HISTORIC AND DESIGN REVIEW COMMISSION

September 06, 2017

HDRC CASE NO: 2017-444
ADDRESS: 1974 S ALAMO ST
LEGAL DESCRIPTION: NCB 1009 BLK LOT 46&47
ZONING: I-2 RIO-7
CITY COUNCIL DIST.: 1
APPLICANT: Lori Orr
OWNER: Hugh Horne/Hornse RPC Storage
TYPE OF WORK: Construction of a street facing loading dock
REQUEST:

LANDSCAPE PLANTING PLAN

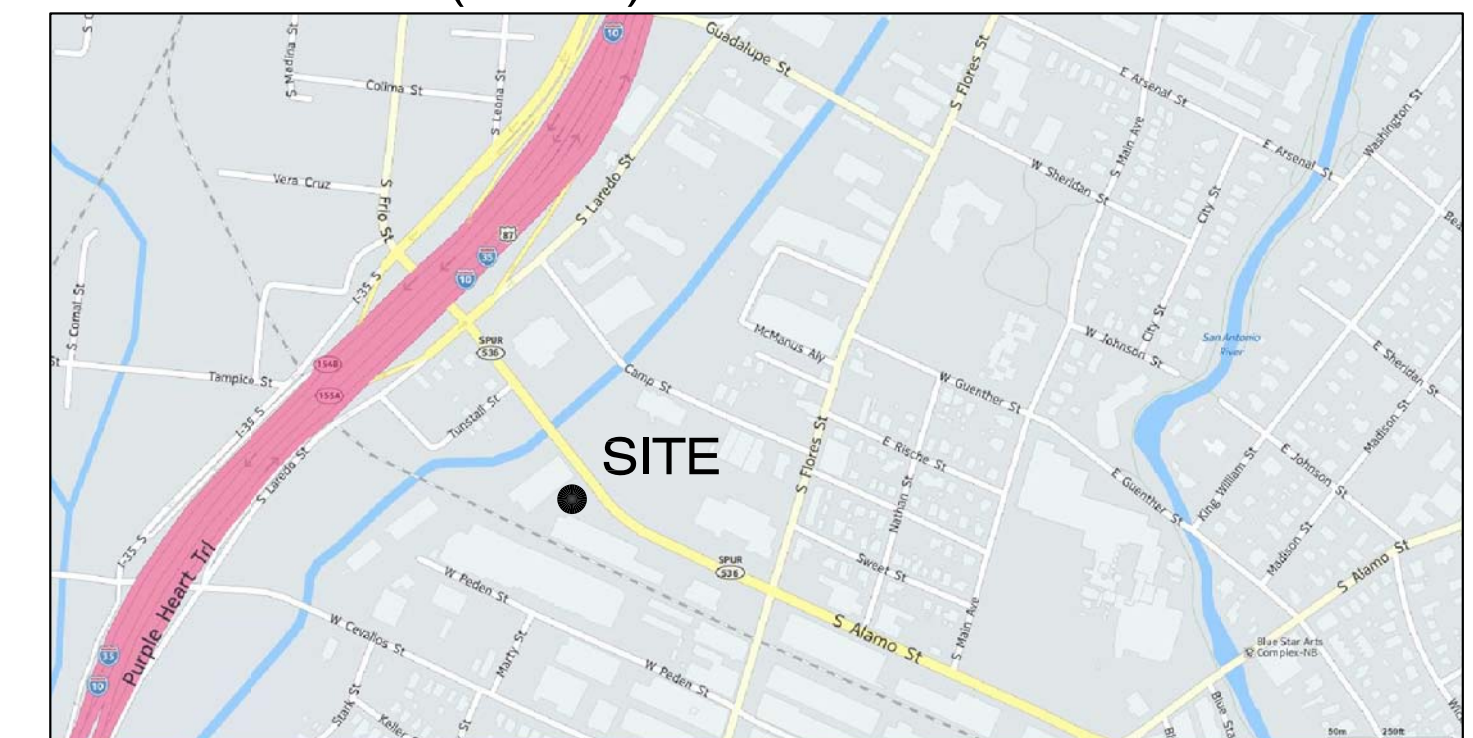
- d. **SITE WORK** – The applicant has proposed site work which includes the installation of landscape buffers between the existing parking lot and the public right of way. The applicant has also proposed improvements to the existing parking lot. The proposed improvements are consistent with the Guidelines; however, the applicant is to provide a list of landscape materials to staff.

| ISSUE | DATE | SHEET NUMBER |
|------------------------------------|-----------|--------------|
| SHEET TITLE EXTERIOR ELEVATIONS | | |

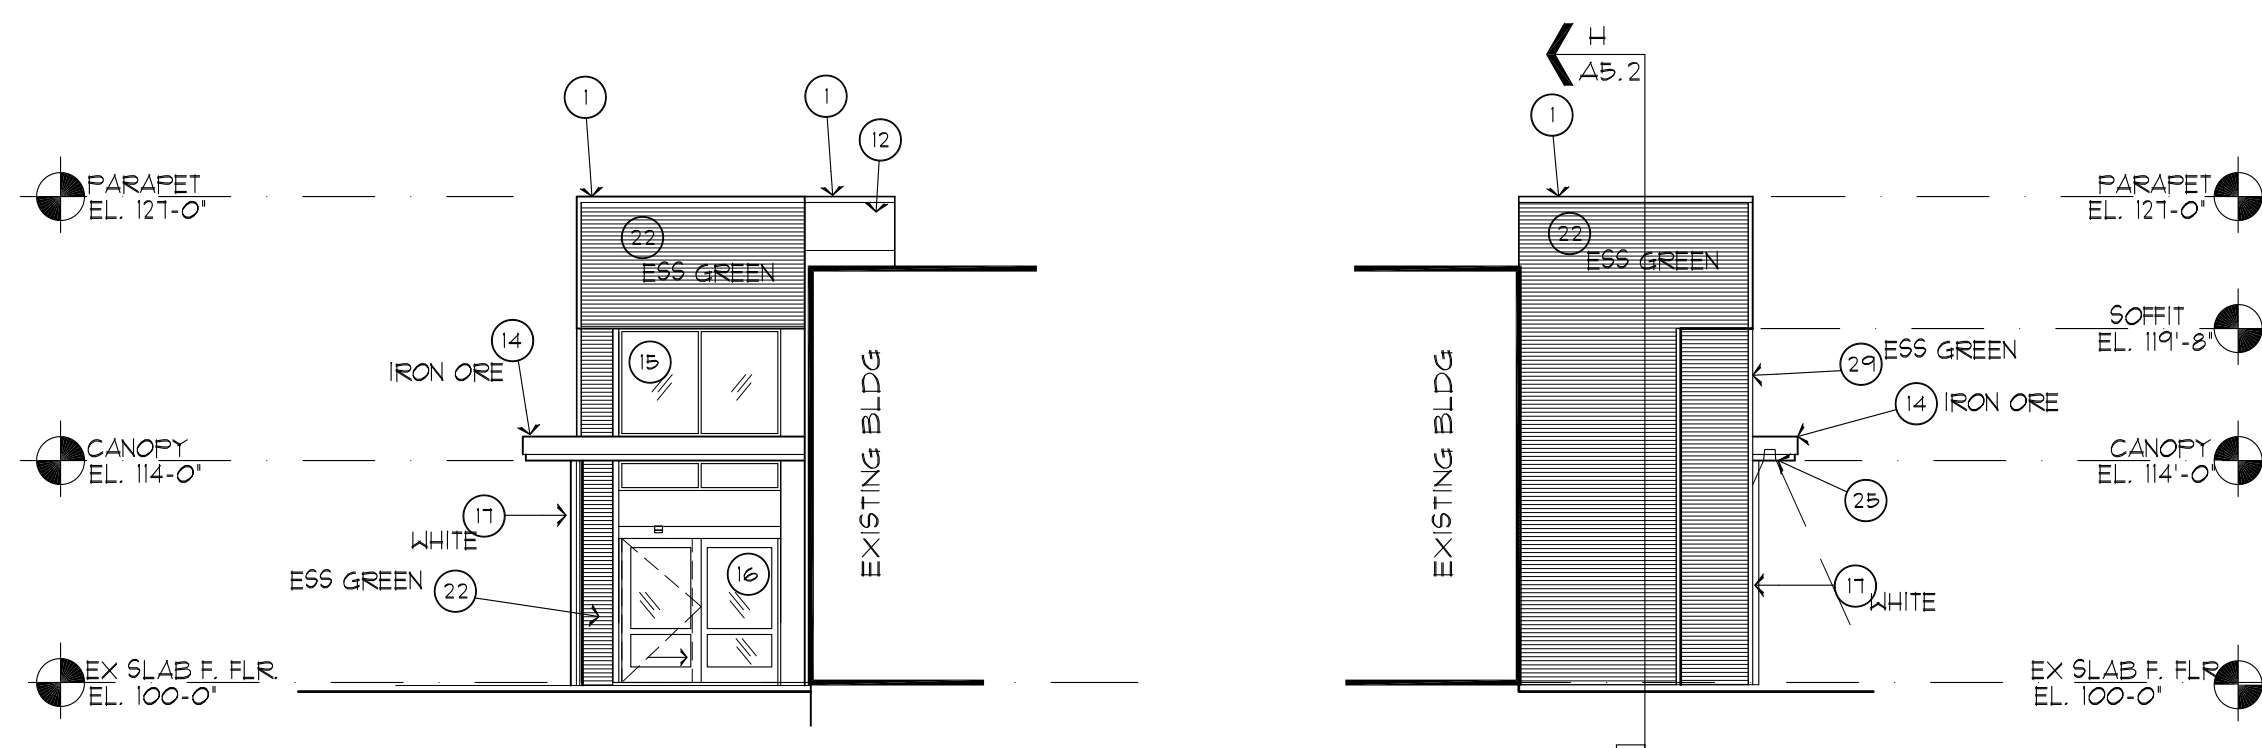
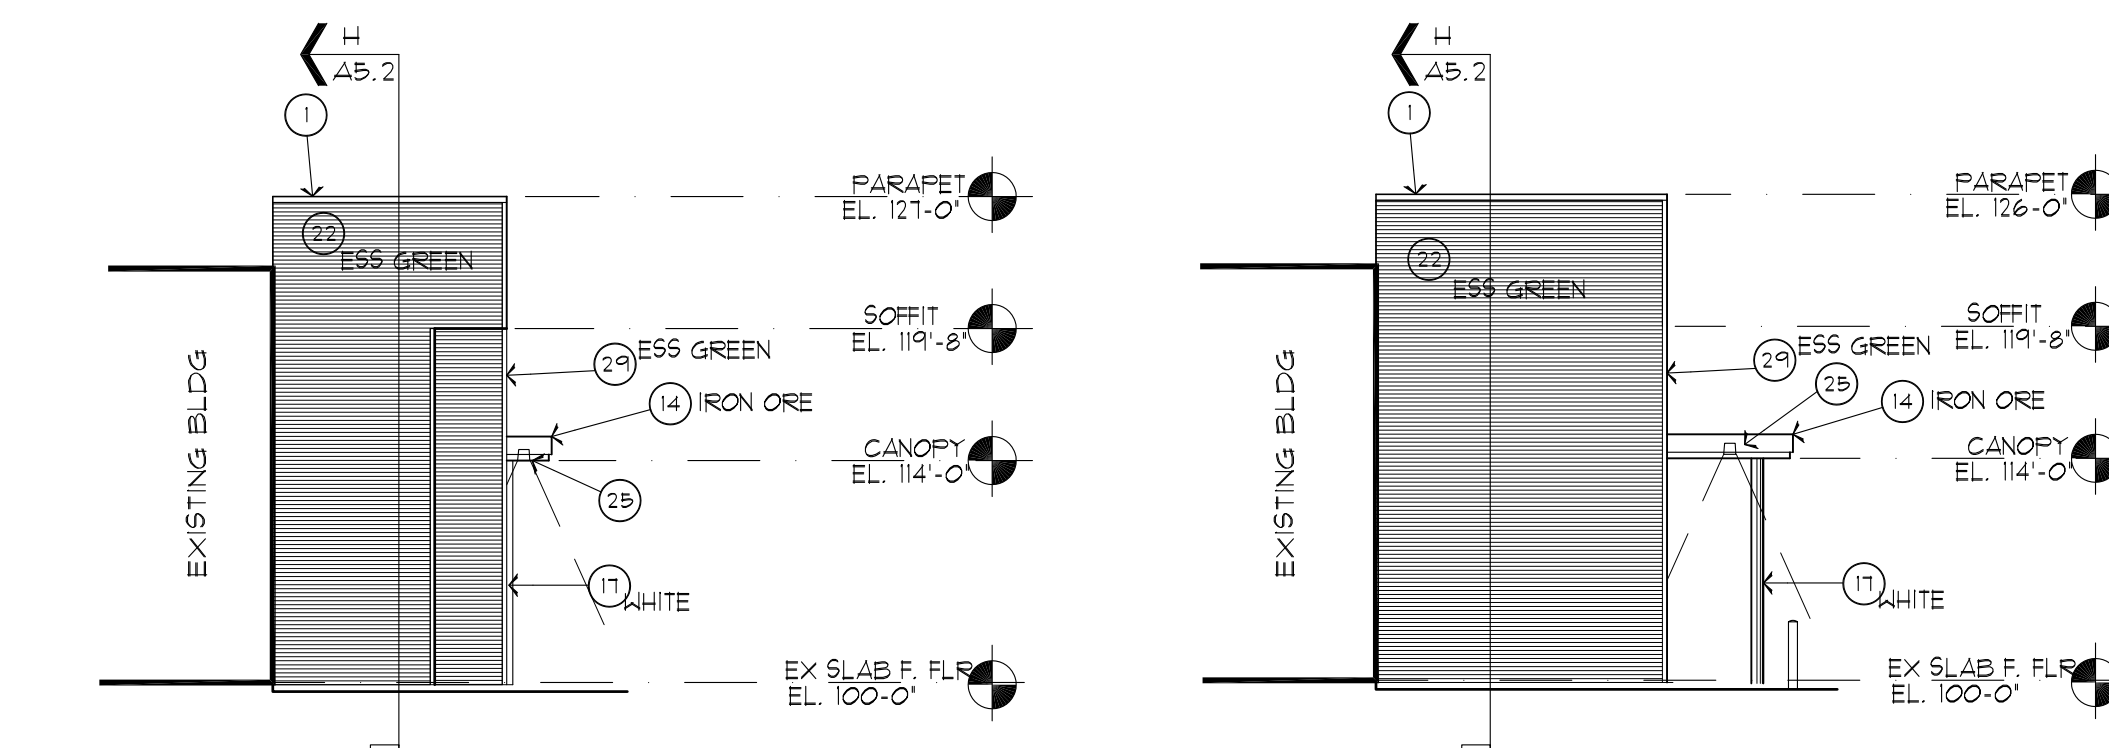
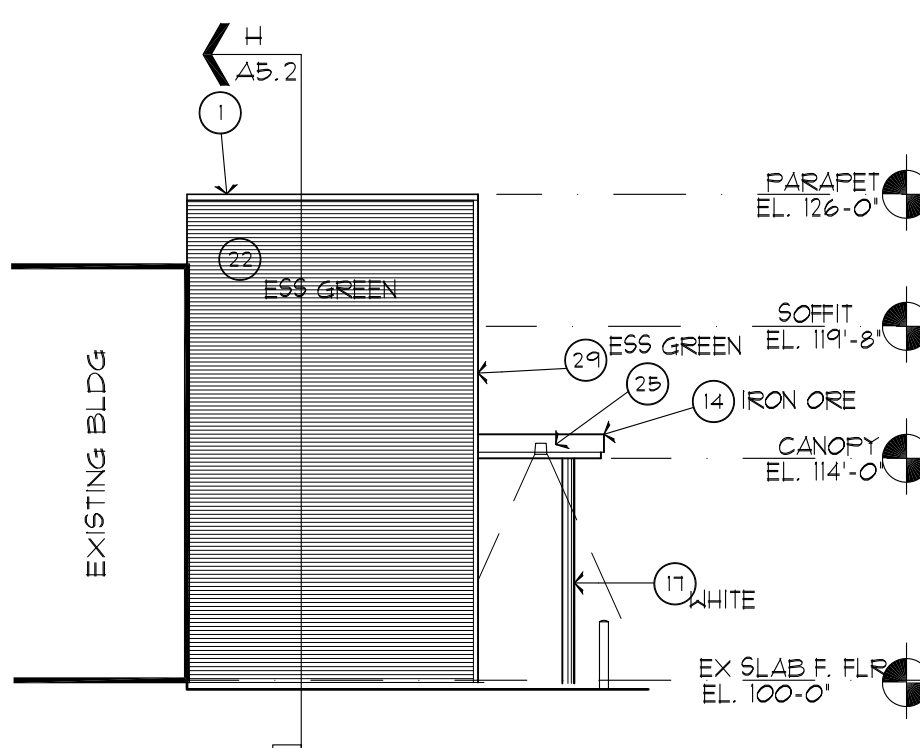
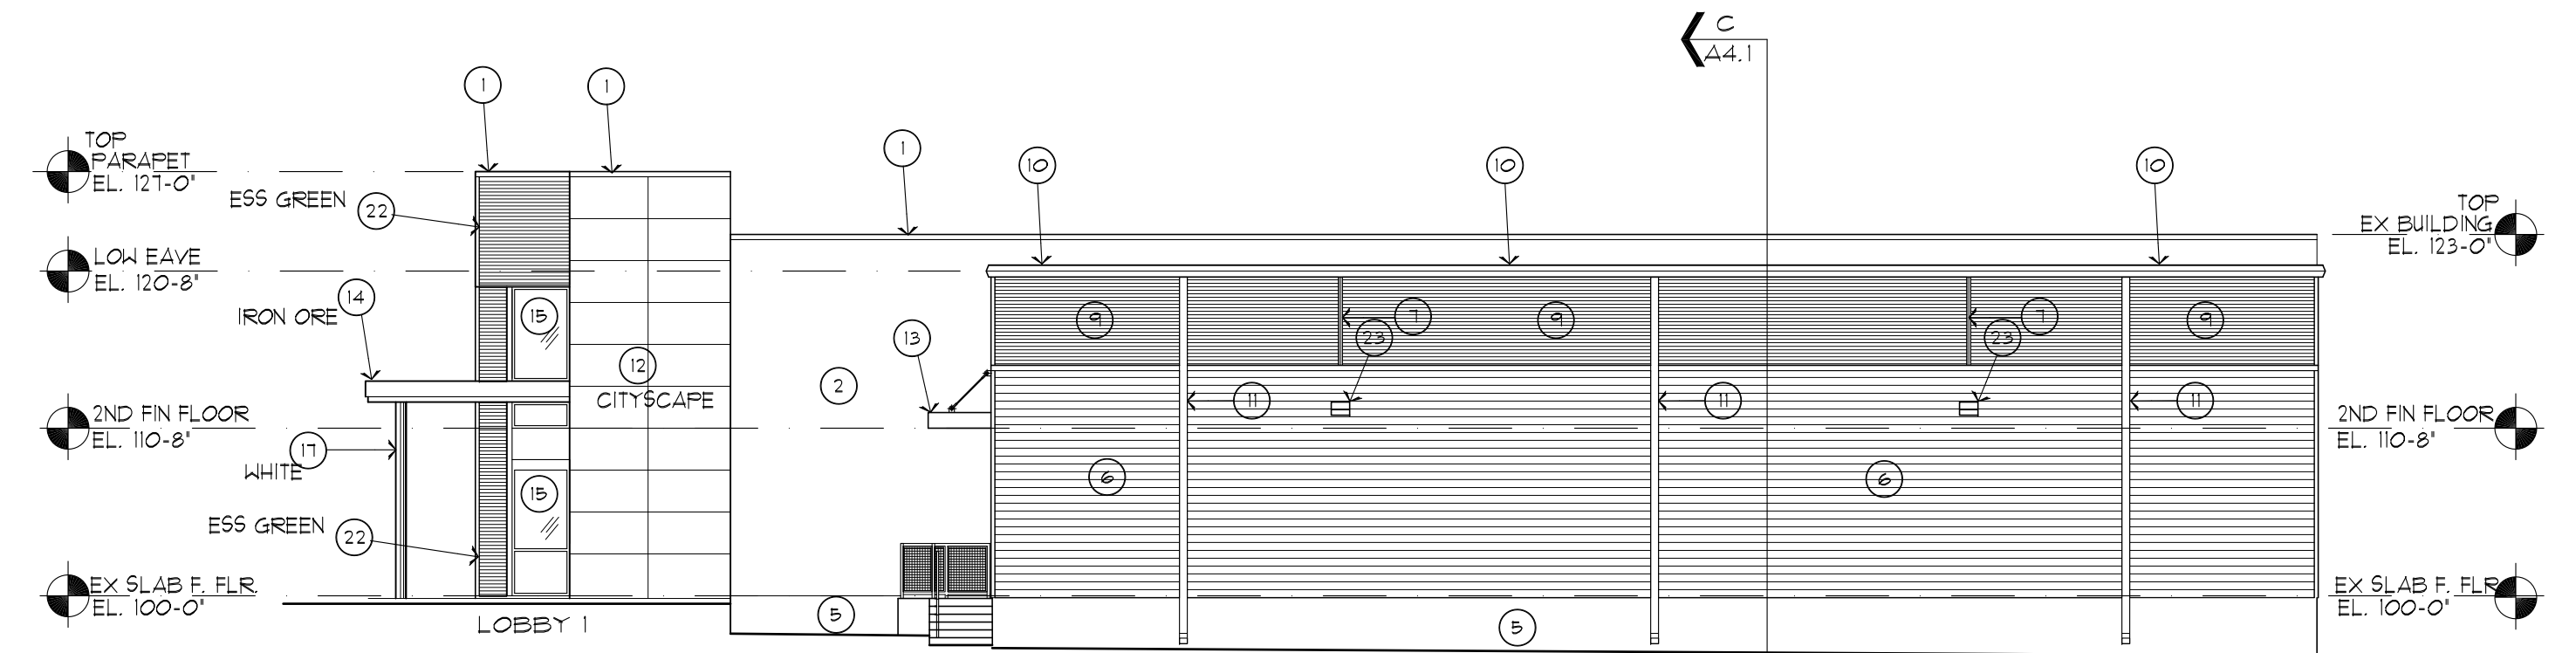
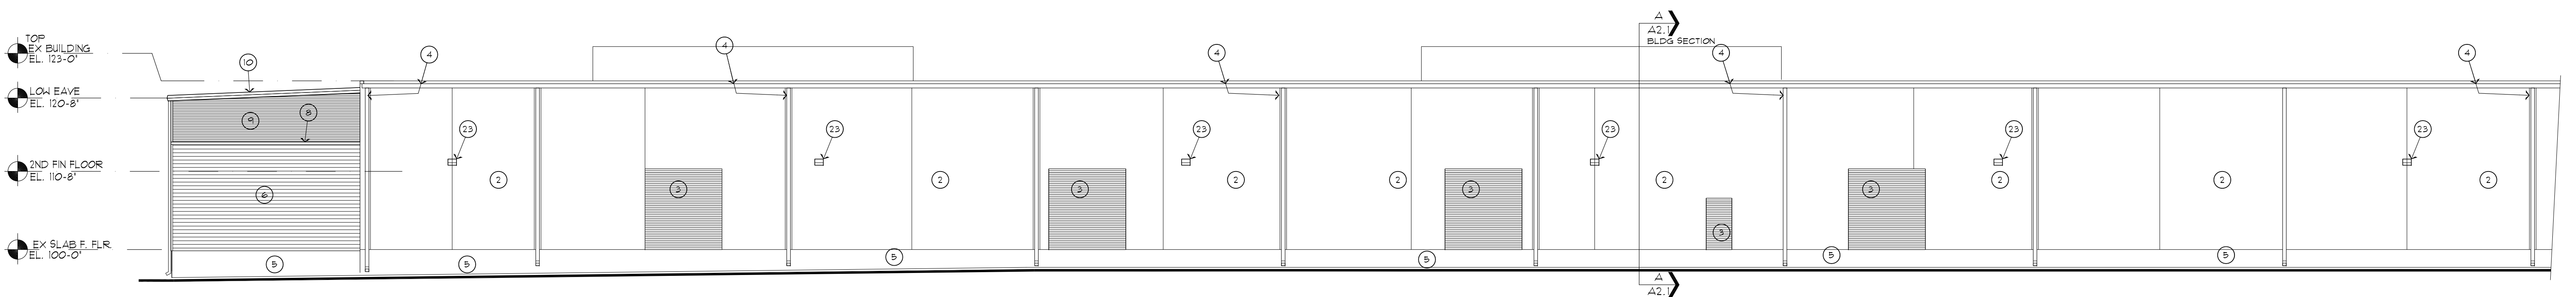
Staff recommends approval of items #1 through #3, the construction of four additions and site improvements with the following stipulations:

- i. That the proposed EIFS panels be eliminated and replaced with stucco or a composite panel material.
- ii. That the applicant provide staff with a list of landscape materials to be installed.
